MEMORANDUM

To: Expert Consenting Panel – Ashbourne From: Michelle Seymour
Commute Transportation Consultants

Subject: Transport Assessment of updated development proposal for Ashbourne

Figure 4-1: Previous Road Layout in Stage 6

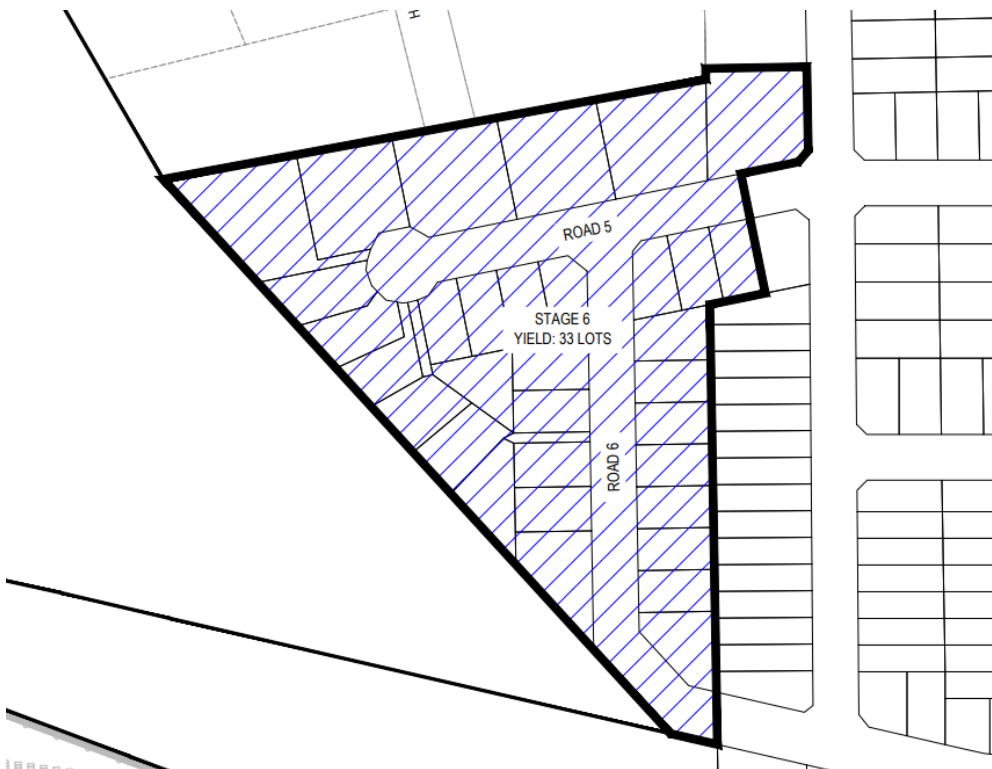
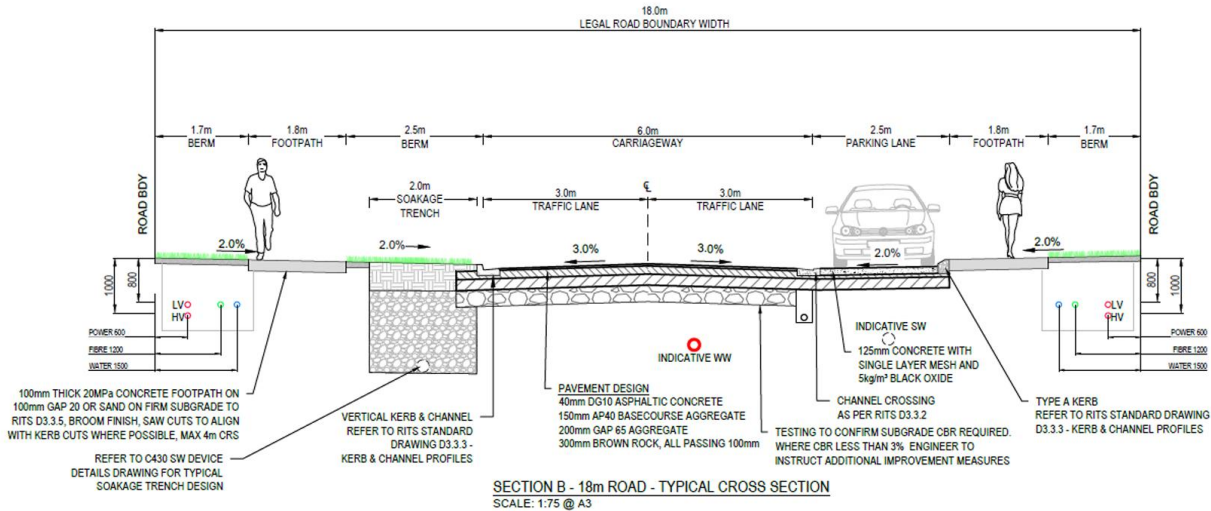
The updated road network is predominantly the same as that assessed within the ITA. The changes to the road layout with Stage 6 are shown in Figure 4-1 and Figure 4-2 below. These changes include the provision of a cul de sac at the termination of Road 5, and the removal of a give way intersection at Road 6, and a new give way intersection between Road 5 and Road 6.

Detailed vehicle tracking has not been completed for the road layouts as shown; however, the proposed layout is considered appropriate. It is recommended that a condition of consent require detailed vehicle tracking to be undertaken at the detailed design stage to confirm appropriate vehicle manoeuvring.

Figure 5-1: Access Arrangements in Stage 6

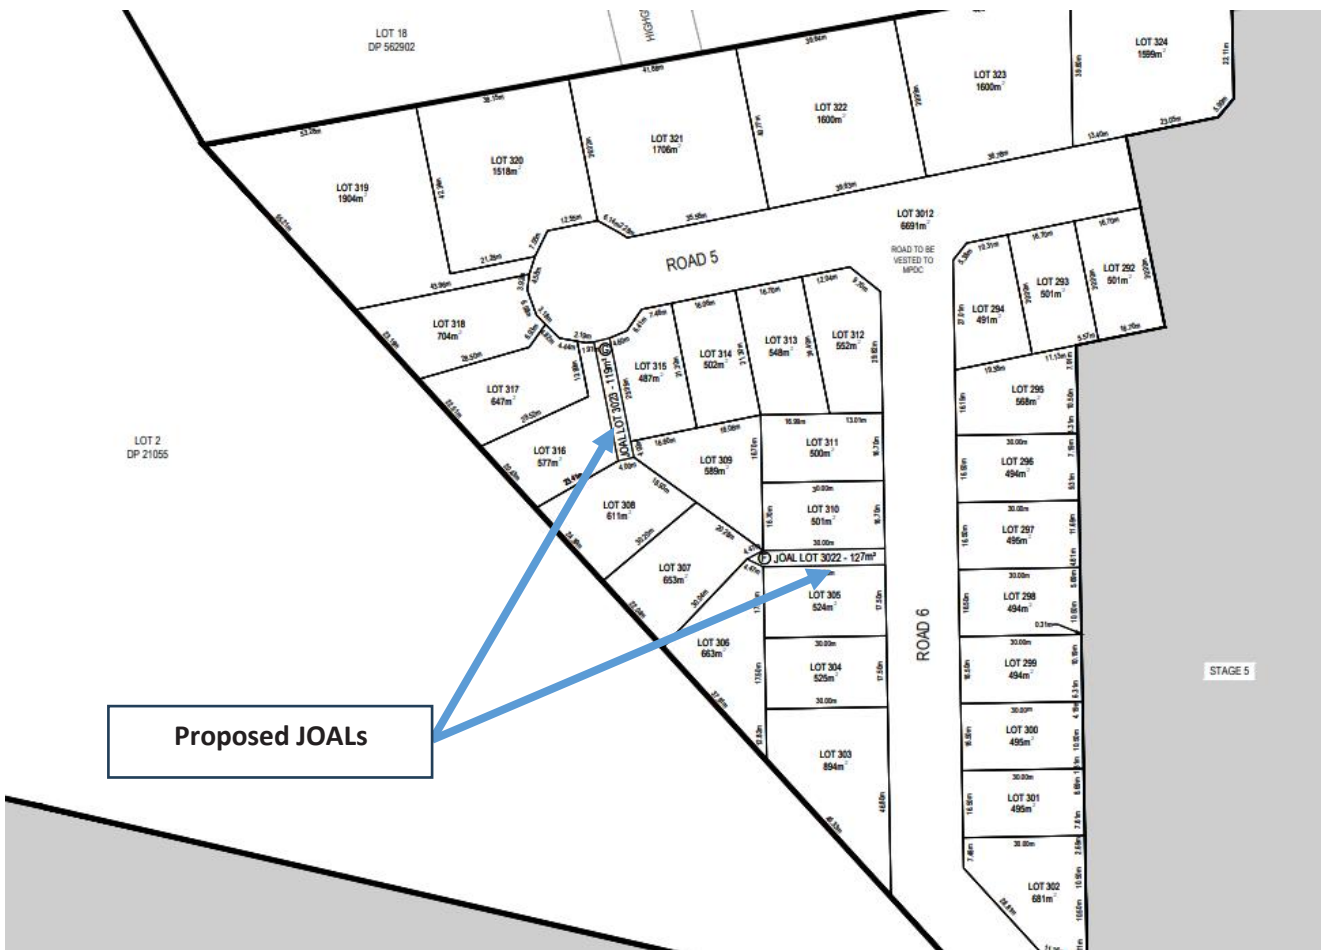
Within Stage 6, two new Joint Owned Access Lots (JOALs) are proposed as shown in Figure 5-1. The JOAL widths are 4.0m, and serve two dwellings each, and as such are compliant with Table 3.1 of the MPDCDM.
